MFN 10-044 Supplement 3

Docket No. 52-010

Subject: Revised Response (Revision 3) to NRC Request for Additional Information Letter No. 411 Related to ESBWR Design Certification Application – Engineered Safety Features – RAI Number 6.2-202 Supplement 1

Revised Response (Revision 3) to NRC Request for Additional Information Letter No. 411 Related to ESBWR Design Certification Application

Figure 6.2-202 M1

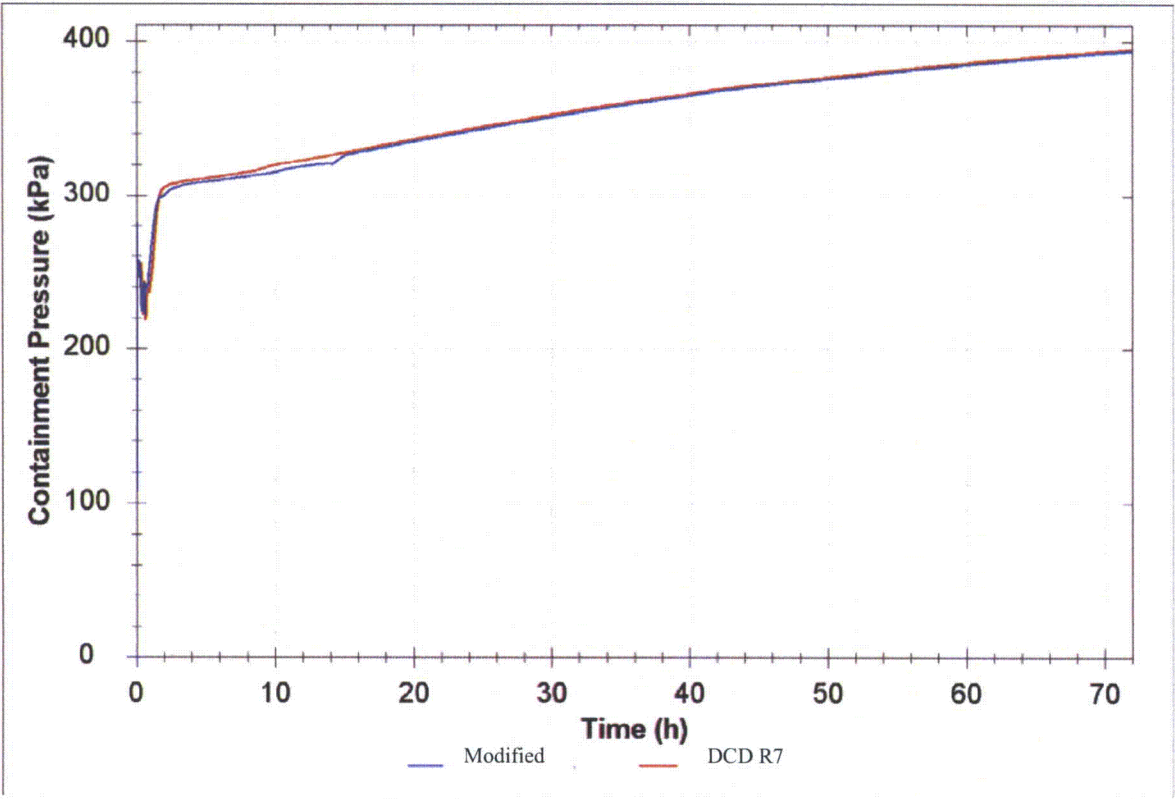
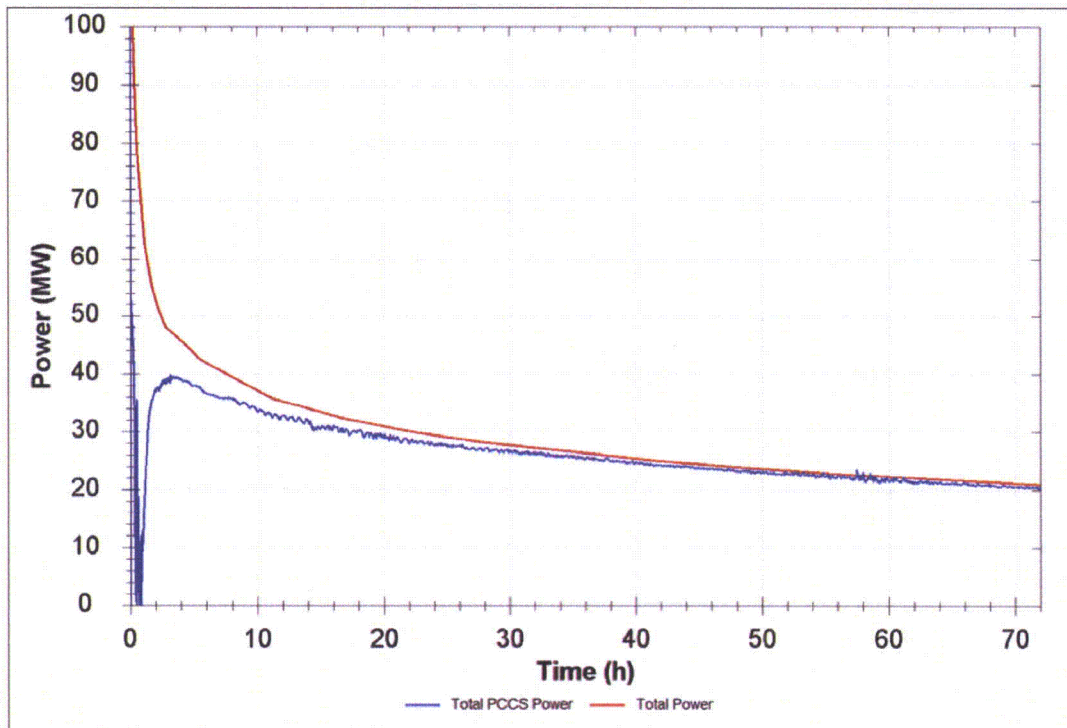
The results of the TRACG analysis that includes the change in tube material, number of tubes, tube thickness and tube inner diameter is presented in Figures 6.2-202 M1 and 6.2-202 M2. Figure 6.2-202 M1 presents the containment pressure response for the updated TRACG analysis vs. the containment pressure for the TRACG analysis in the DCD Tier 2 R7 Figure 6.2-14j1. They are approximately the same and the modified analysis has a slightly lower maximum pressure than the DCD Rev 7 analysis. Figure 6.2-202 M2 presents the PCCS power for the updated TRACG analysis. The PCCS power is similar to the PCCS power presented in the DCD Tier 2 R7 Figure 6.2-14l1 (Figure 6.2-202 M3). The difference in the curves in each of these figures is due to uncondensed steam flowing to the wetwell from the drywell in the early blow down and from the PCCS in the long term. The figures show that the difference between the decay heat and PCC power in the LOCA transient is similar for the DCD Rev 7 and modified design.

As seen in Figure 6.2-202 M1, the changes to the PCCS did not affect the TRACG results for containment pressure. The updated analysis shows that the long term LOCA response remains approximately the same as the previous analysis. This is because the wall thermal conductivity decrease offset the surface area increase. The PCCS continues to operate below its 100% steam capacity rating (47 MW total rated capacity for 6 PCCS condensers) in the long term (6-72 hour period) DBA LOCA as indicated by the Total PCCS Power in Figure 6.2-202 M2. It is operating below its 47 MW (7.8 MW

per unit) capacity during the DBA LOCA. The integral PANDA tests included all of the features required for an integral system simulation for a long term LOCA response. Figure 6.2-202 M2 shows the PCCS power, which in comparison to the DCD R7 PCCS power (Figure 6.2-202 M3) is similar, and therefore, the integral long term LOCA response of the system will remain the same and PANDA tests are still applicable..
